# Creamery Road PSP

## Review of Villawood Designs

Prepared for: City of Greater Geelong

Ref: 300305978

Figure 3-1: Councils FUS (adopted August 2024) compared with the Proposed Villawood FUS

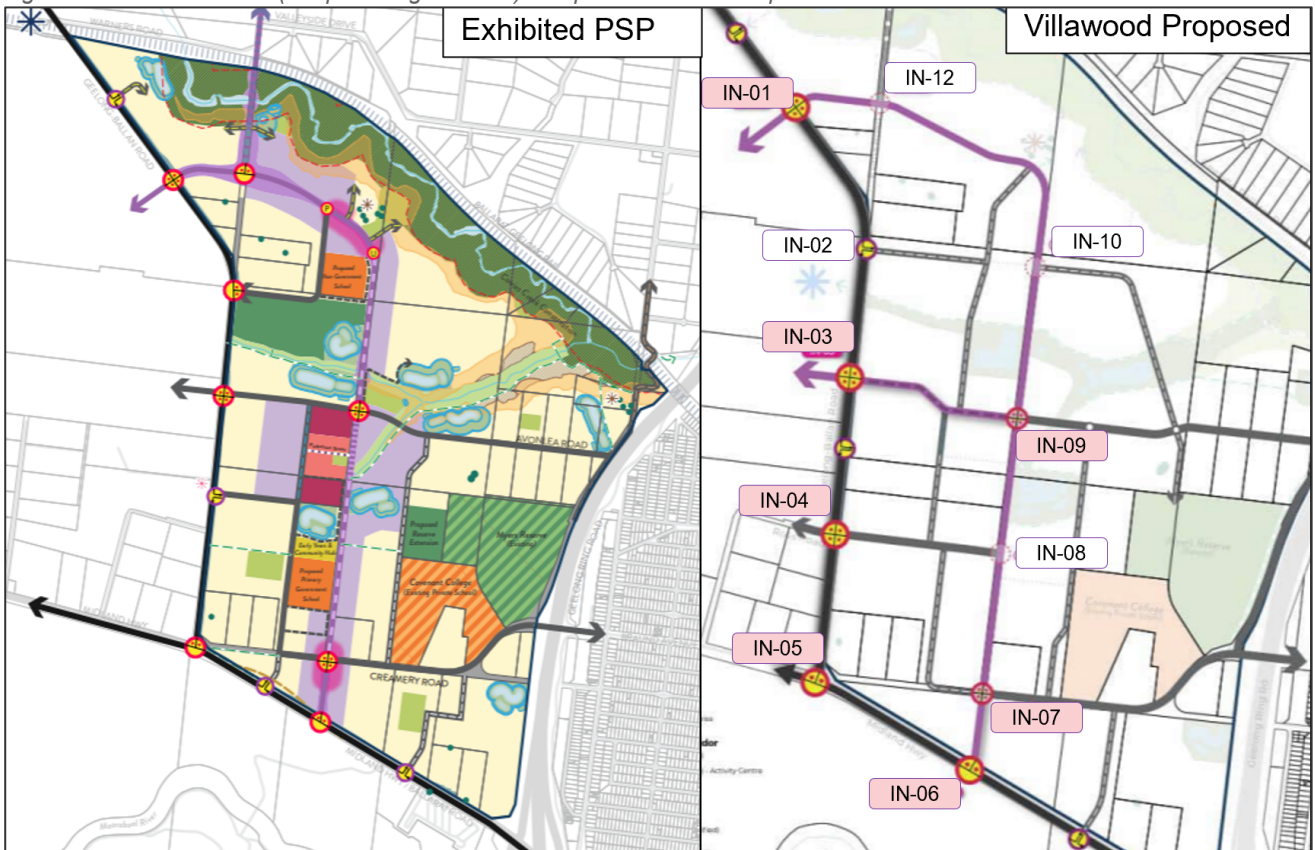
- Removal of Left-in-left-out (LILO) Intersection Between IN\_05 and IN\_06. The LILO access originally shown in the PSP FUS has been removed in the Villawood version.

- CC\_08 has been added along the CCC in the Villawood FUS, which was not included in the Councils FUS (adopted August 2024).
- CC\_10 is also newly introduced into the Villawood FUS, along with a new eastbound local connector road. It is not clear if this is to be a DCP item or not.

- Between IN\_03 and IN\_04 a new left-in left-out intersection has been added.
- The PSP FUS shows CC\_12 as a signalised T-intersection, whereas the Villawood FUS proposes an unsignalized intersection but they have also provided designs for a fully signalised intersection.

- IN\_04 has been upgraded from a left-in left-out to a signalized intersection.
- The Villawood FUS includes a revised road layout configuration in the vicinity of the activity centre.

- The Villawood FUS shows a modified alignment of the CCC between CC\_10 and CC\_12, reflecting the removal of provisions for C and U-turns, which were considered in the PSP FUS.

- The Villawood FUS includes the reframed CCC between CC\_09 and IN\_03 and beyond into the Batesford North PSP.
- The location of CC\_12 is located further south in the Villawood proposed FUS compared with the Councils FUS (adopted August 2024).

Figure 3-2: CCC Road Reserve 27.9m - Villawood proposed cross section

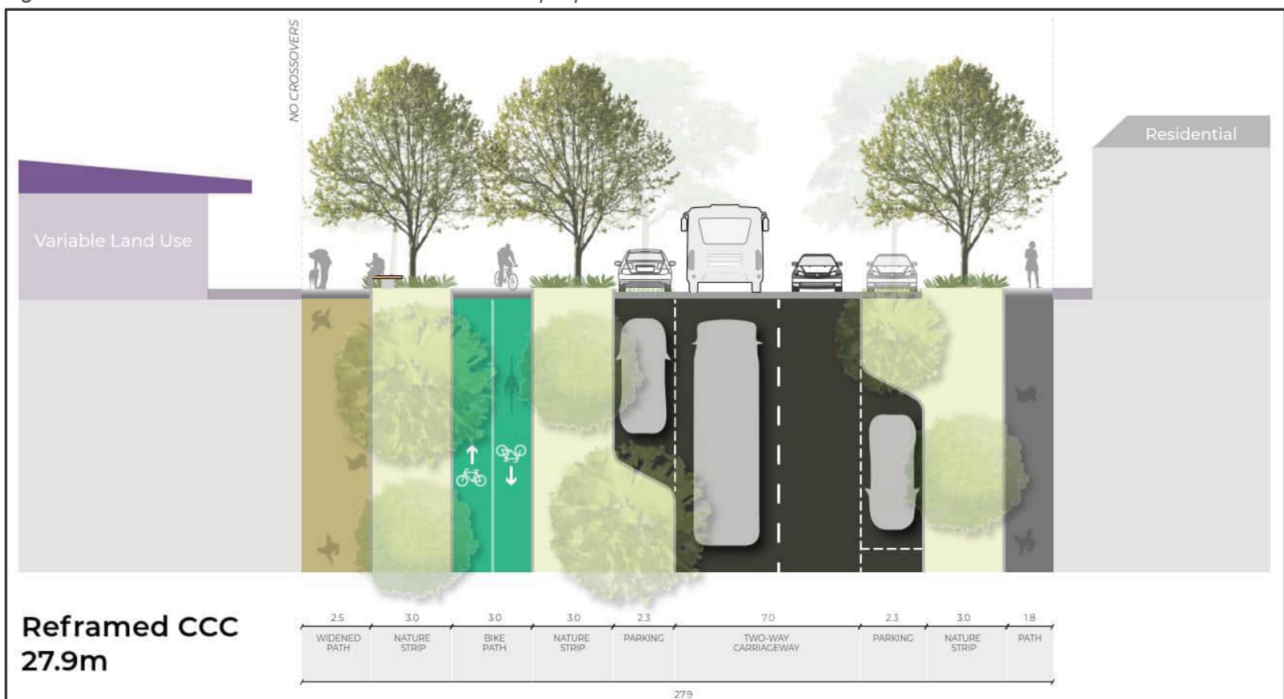
The Villawood Design utilises a 27.9-metre-wide road reserve, reflecting the removal of dedicated public transport lanes, which eliminated the corridor's capacity to accommodate midblock bus lanes, consistent with the direction of the SAC. The design provides only a 1.8-metre-wide footpath on one side of the road and a widened path the same side as a dedicated bidirectional bicycle lane.

Noting the position of the SAC which states: “The Urban Connector street typologies in the PSP should be updated to reflect Villawood’s ‘Reframed CCC’ cross section, with lot access limited along the side with the bicycle path.” It is clear that the cross section proposed delivers on this direction.

Figure 3-3: Connector Road 25m Road Reserve - Villawood Preferred

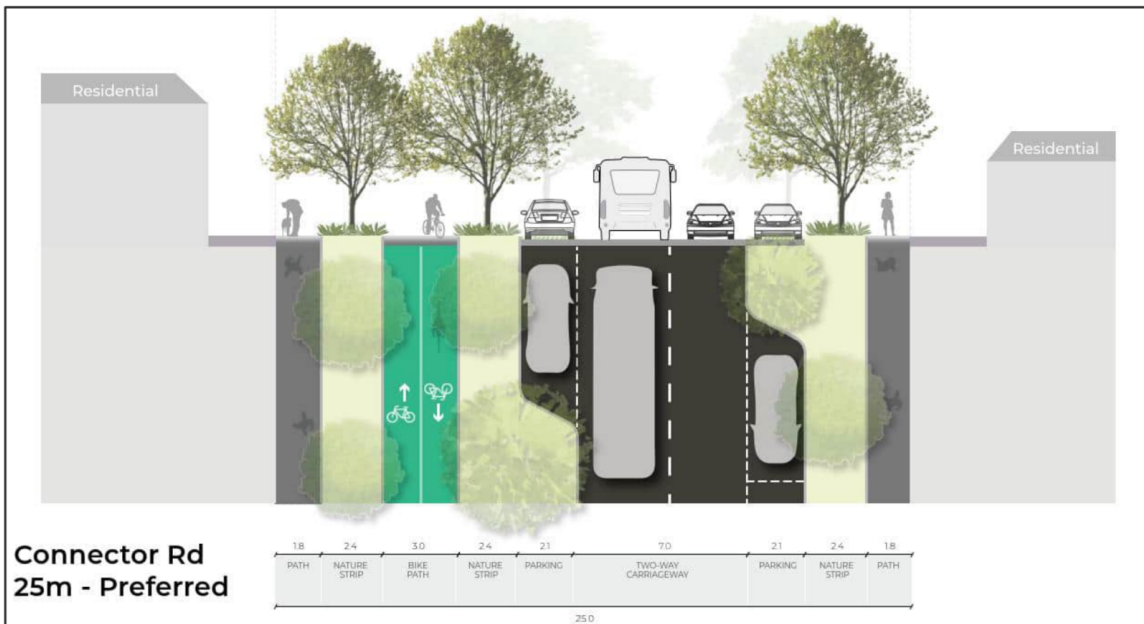
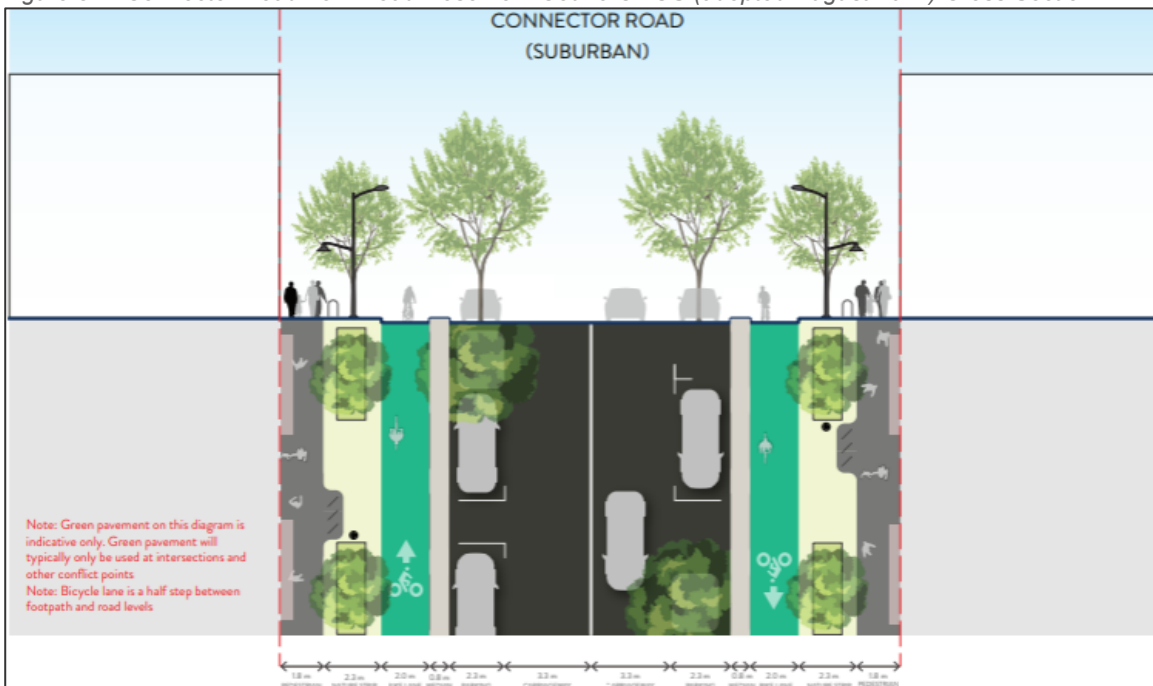
Element	Councils FUS (adopted August 2024)	Villawood Proposed
Bicycle Infrastructure	Dedicated 2.0m-wide bicycle lanes on both sides of the road.	Replaces dual lanes with a 3.0m-wide shared path, potentially reducing clarity and safety for cyclists and pedestrians.
Parking Bays	<b>2.3m-wide parking bays</b> , allowing safe clearance from footpaths and bicycle lanes.	<b>2.1m-wide parking bays</b> , increasing risk of vehicle overhang into adjacent paths.
Footpaths	<b>1.8m-wide footpaths on both sides</b> , supporting high pedestrian volumes and accessibility.	<b>1.8m-wide footpath on the eastern side only</b> , which may not meet accessibility or shared use standards.
Nature Strip / Verge	<b>4.4 m nature strip space</b> , designed for landscaping, tree planting, and public realm features.	<b>7.2m nature strip</b> , aimed at improving canopy coverage.

These differences highlight the need for further review and alignment with the PSP’s strategic intent, particularly to ensure the Connector Road supports safe, accessible, and future-ready transport infrastructure.

The proposed Villawood design provides a bidirectional bike path located on one side of the corridor. While bidirectional bicycle paths can be beneficial in constrained corridors or low-conflict environments, they introduce greater complexity at intersections and driveways, often requiring additional signalisation and careful design to manage safety and flow. They may also reduce accessibility to properties on the opposite side of the road and complicate pedestrian crossings.

Given the original PSP intent and the operational advantages of unidirectional paths, this report recommends reconsidering the bidirectional treatment with unidirectional bicycle paths to better support safety, connectivity, and long-term network integration.

Figure 3-8: Evans Road - Villawood Proposed Cross Section

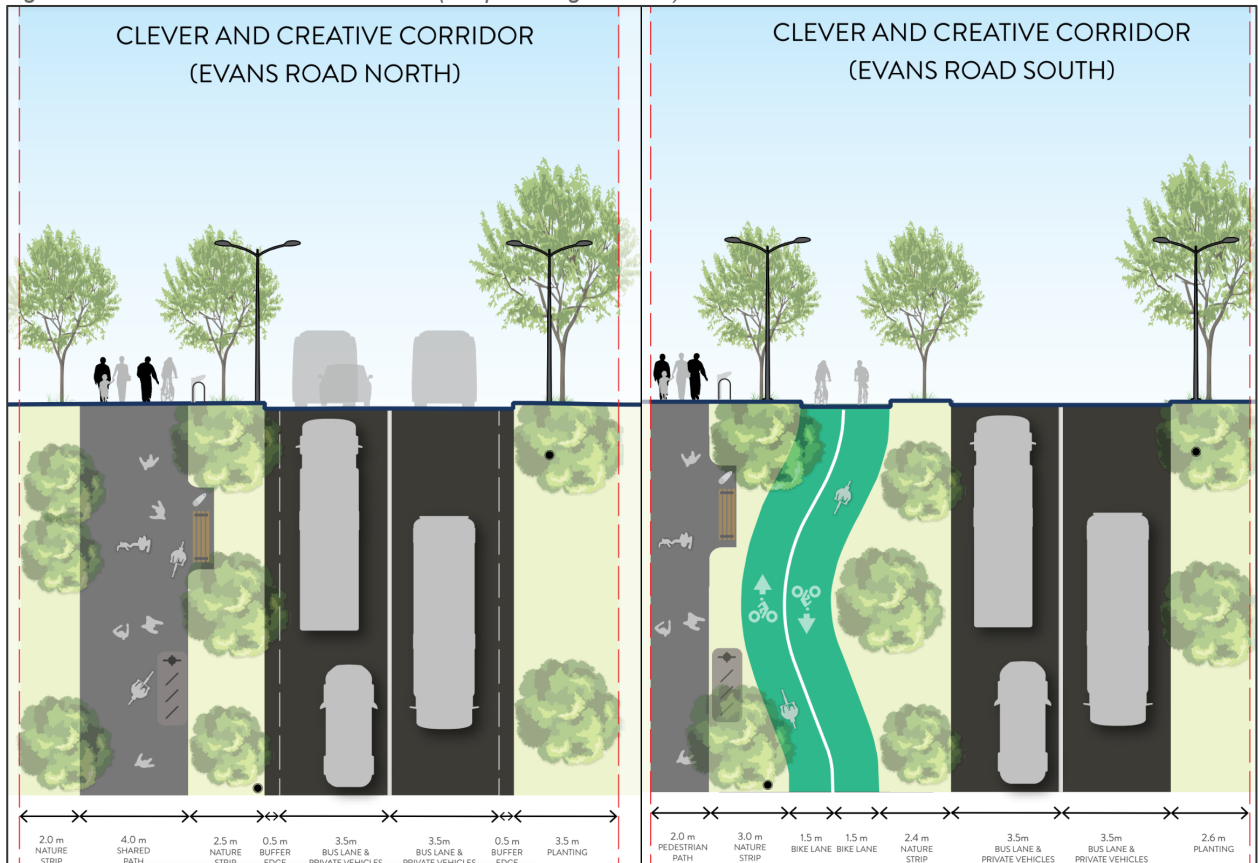
Element	Councils FUS (adopted August 2024)	Villawood Proposed
Road Segmentation	<b>Divides Evans Road into northern and southern</b> sections with tailored cross-sections.	Applies a <b>single cross-section</b> for the corridor within the PSP.
Shared Path (outside of PSP Boundary)	Includes a <b>4.0m wide shared path</b> with a 0.5m buffer edge lane.	Proposes a <b>3.0m wide shared path</b> , combining pedestrian and cyclist movements.
Shared Path (inside PSP Boundary)	Features a <b>3.0m wide designated bicycle lane</b> and a <b>2.0m wide footpath</b> .	Proposes a <b>3.0m wide shared path</b> , combining pedestrian and cyclist movements.
Footpath Provision	Specifies <b>footpaths on both sides</b> , with widths tailored to section function.	Includes a <b>1.8m footpath only on the eastern side</b> , which is not specified in the PSP.
Parking Bays	None	Proposes <b>2.3m wide parking bays</b> , not detailed in the PSP cross-section.

Nature Strip	Allocates a <b>larger nature strip</b> , with 0.6m more width than the OneMile design.	Reduces nature strip width, potentially impacting landscaping and canopy targets.

Evans Road will play an important role in connecting the Northern and Western Growth Areas and ensuring that it has the appropriate elements to deliver on its role and function will be important. Ultimately, Evans Road will from part of the CCC and cater for traffic volumes in excess of 14,000 vehicles per day and it will be important to ensure that its broader role and function is not compromised.

Evans Road Shared path	The shared path along Evans Road is supported. A wider verge, within and outside of the PSP boundary, could be considered to provide the flexibility for potential widening enabling dedicated bicycle lanes in the future if required.	<u>Given the limited property access on Evans Road, both within the PSP and north of the PSP, it is recommended that a wider verge be provided.</u>
